Technical Service Bulletin

Cobra Motorcycle Mfg.

TSB1012 CX65 Exhaust Flange to Pipe Sealing

March 23, 2012

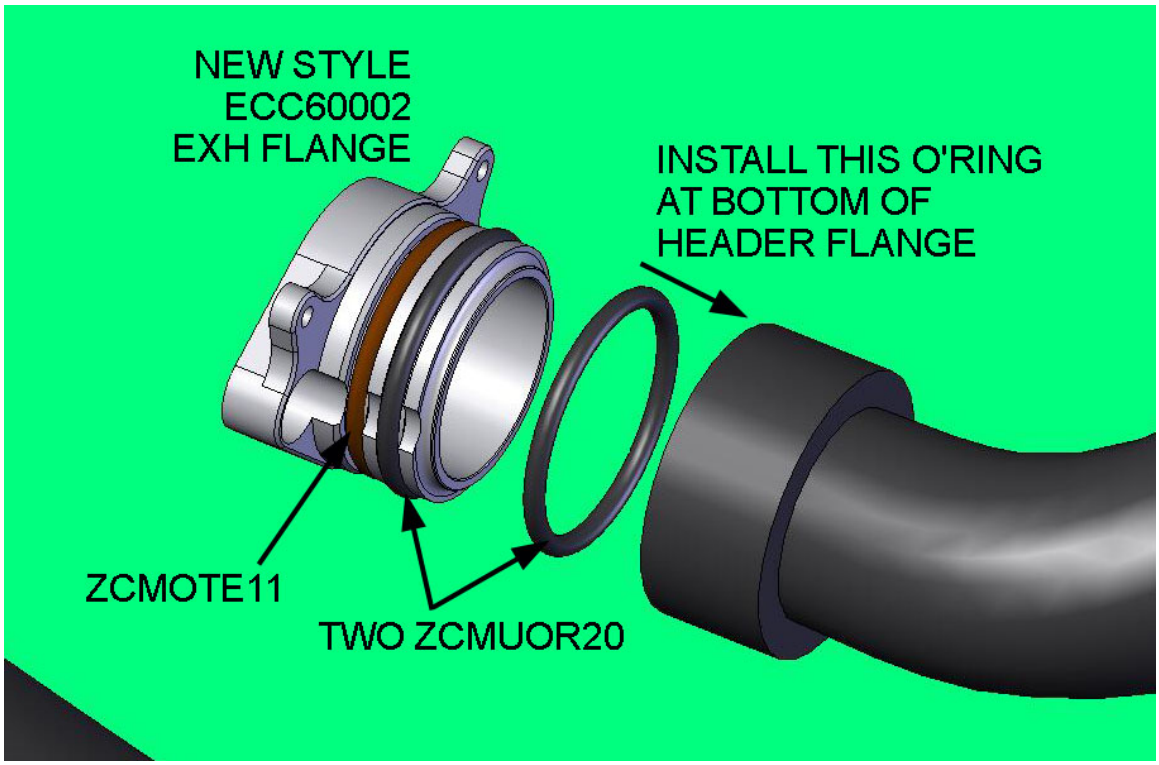
Effective immediately, Cobra CX65 will be shipping with exhaust flange to pipe sealing arrangements as shown below. This seals better and damps noise and vibration.

All service replacement flanges will be of this style for 2007 – 2012 CX65 also.

Please note that there are three o'rings now instead of two. They are not all the same. The o'ring closer to the cylinder is the same old ZCMOTE11 o'ring. The other two (the one mounting on the flange further from the cylinder and the one inserted in the pipe's header flange) are black in color and thicker (ZCMUOR20).
